Section 12A Application No.Y/I-DB/2

For rezoning the permissible use from staff quarters to permit flats at Area 6f, Discovery Bay
Response to Comments (5)

Section 12A Application No.Y/I-DB/2 for rezoning the permissible use from staff quarters to flats at Area 6f
Applicant's response to the departmental comments made available by District Planning Office on 7 March 2017

FIGURE 5

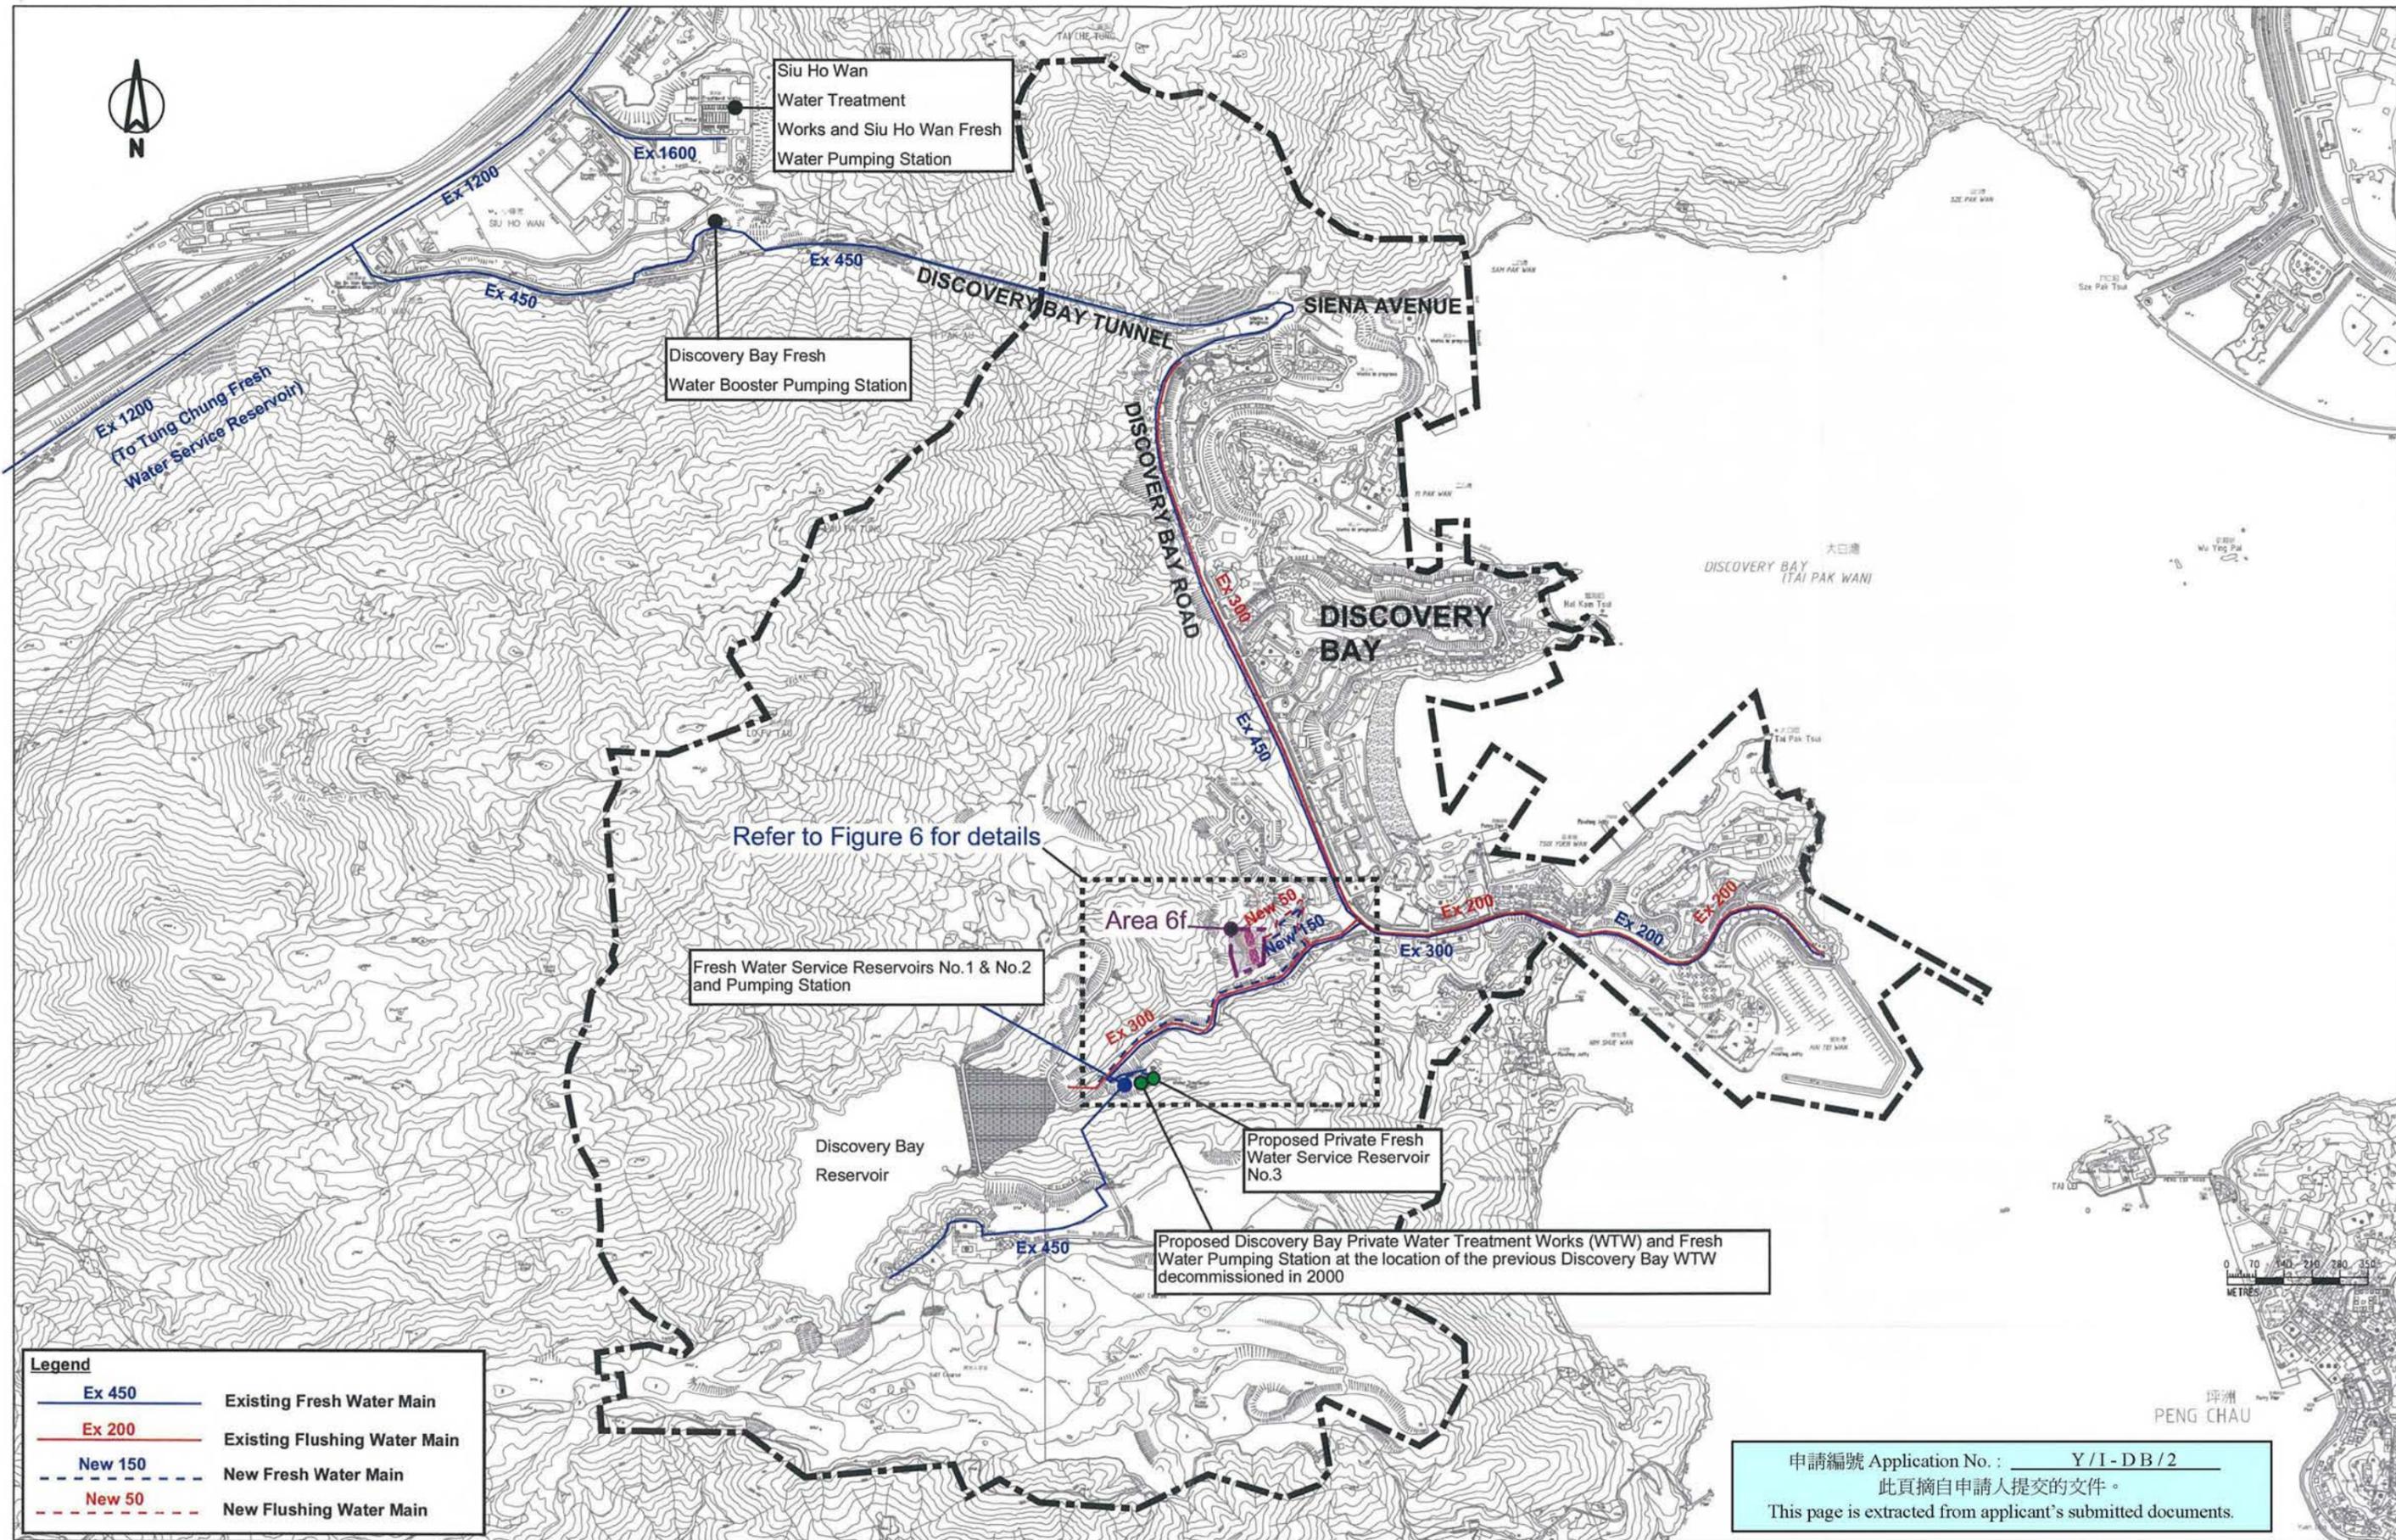
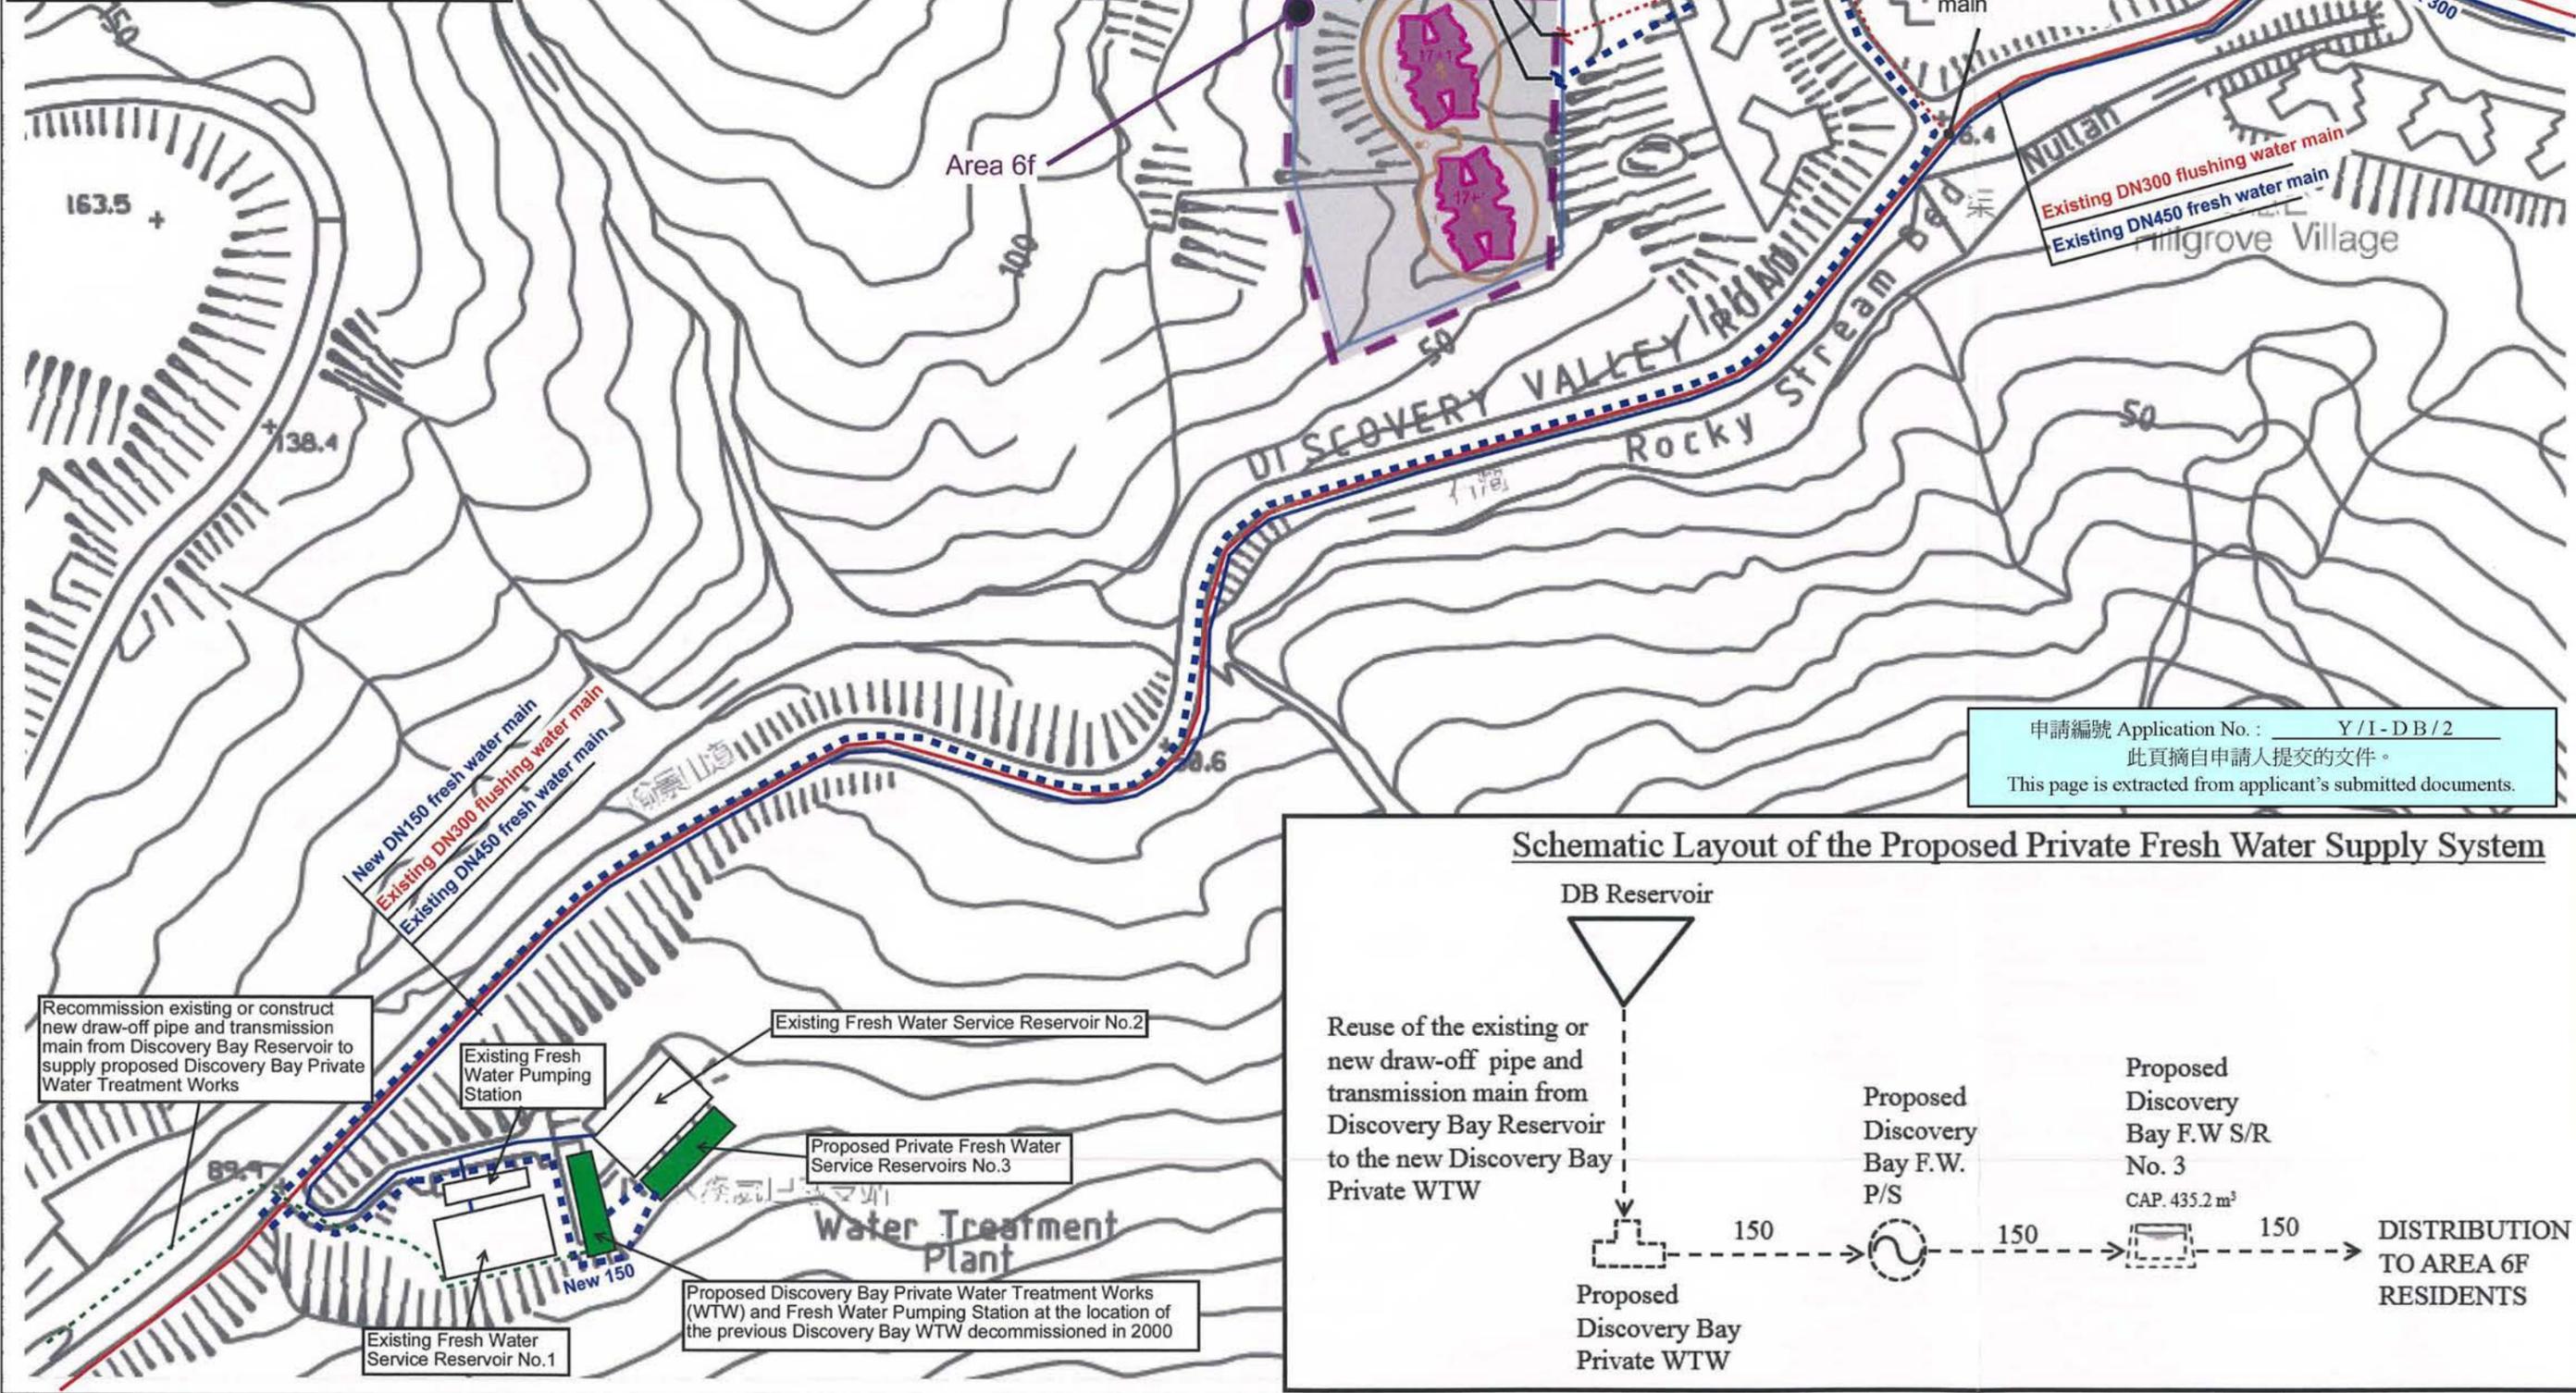
Referring to the Developer's 4th Further Information Submission, there is no drawing showing the Developer's proposed alternative water supply arrangement that involves a private water treatment works and a private fresh water supply network for supplying Area 6f and Area 10b that should be segregated from the existing network supplying WSD fresh water.

Please find Figure 5 and Figure 6 in **Appendix D** showing details of the proposed water supply "Option 2", which involves the provision of a private fresh water supply system to serve Area 6f. Under this water supply "Option 2", raw water will be extracted from the Discovery Bay Reservoir to a new private water treatment works. The treated water will then be transferred via a new pumping station to a nearby new Service Reservoir No. 3. A new fresh water distribution main will be laid from the service reservoir to provide fresh water supply to Area 6f. The entire new private water supply network, comprising water treatment works, pumping station, service reservoir, transmission and distribution mains will be an exclusive network to supply Area 6f only and will be totally segregated from the existing network supplied by WSD's fresh water.

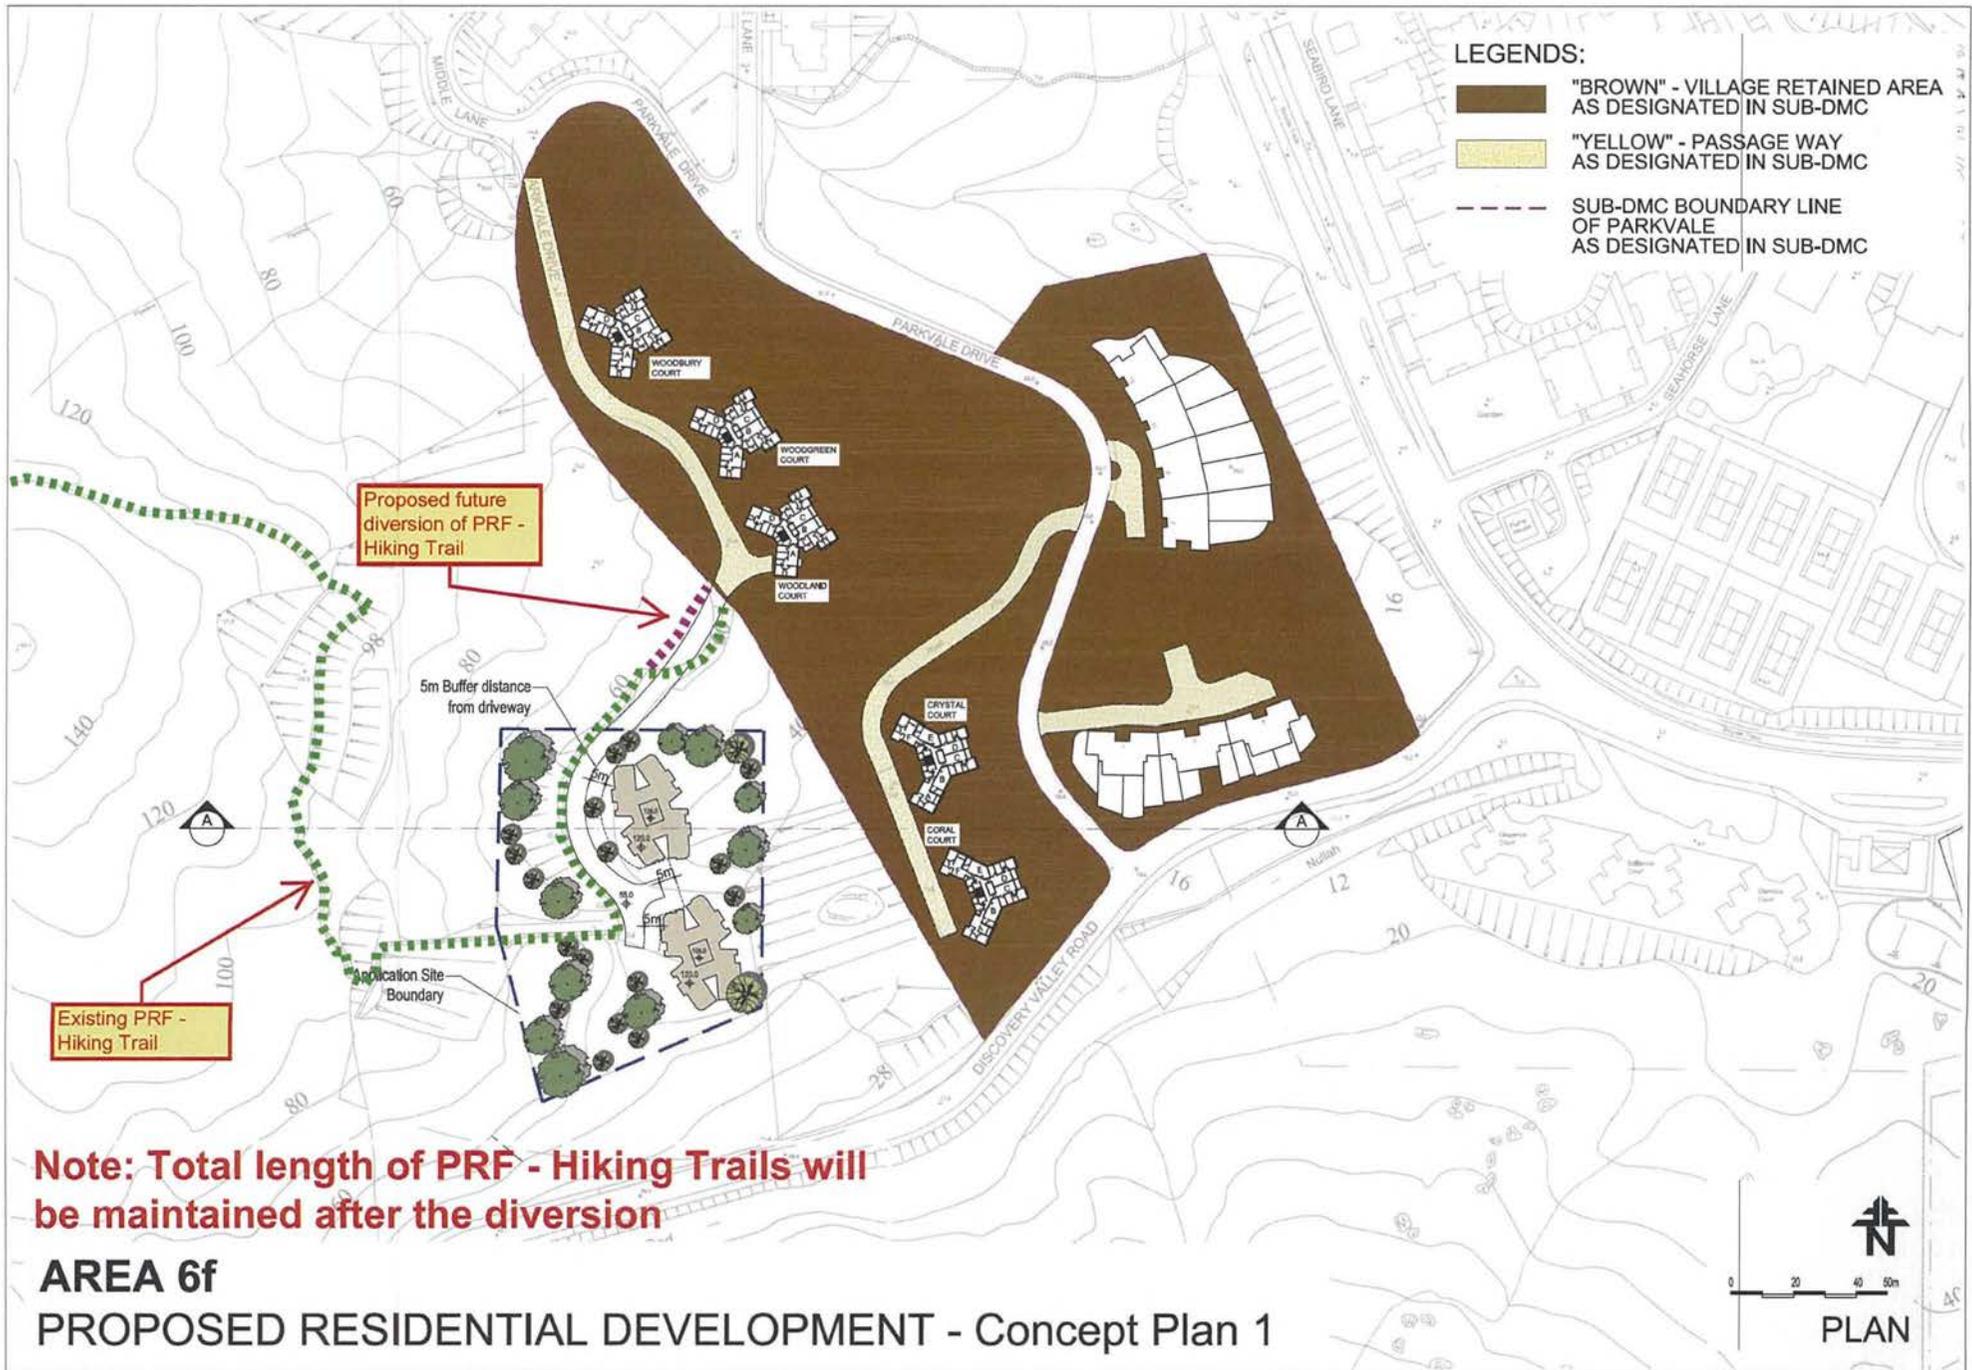
<p>CTP/UD&L, PlanD's comment</p> <p>Please note that under the 2nd FI there was an additional 98 nos. of compensatory trees proposed in the Landscape Design proposal (Rev. B) comparing to the Landscape Design proposal (Rev. 0). The revised proposal of 148 nos. compensatory trees was not clearly indicated in Fig B1 Landscape Design Plan. An insufficient planting space was also noted on the Landscape Master Plan (Figure B.1). We have doubt that if the development site could accommodate such large number of compensatory trees. The applicant should review critically the total number of compensatory tree planting within the site.</p> <p>The impact on existing trees is based on the assumption that no slope work is necessary. As the western slopes are quite steep, should the risk factor changed due to residential development and render slope work necessary, the scope of works and impact on trees should be re-visited.</p>	<p>Applicant's response</p> <p>The 148 no. compensatory trees were proposed for the total aggregate girth of the affected 118 no. trees. In view of this comment, a more detail study has been carried out as shown in Appendix B. It shows that about 125 no. compensatory trees definitely fit into the site with good separation distance. Detail design will possibly accommodate more compensatory trees at the site. The 125 no. compensatory trees are more than the 118 no. affected trees (and therefore achieve a greater than 1:1 compensatory ratio by number).</p> <p>Given the vegetated slopes within the site that will be retained, and the site context with large areas of existing woodland outside the site boundary, the 125 no. compensatory trees proposed are considered reasonable and adequate.</p> <p>Noted. The impact will be re-visited at building plans preparation stage.</p>
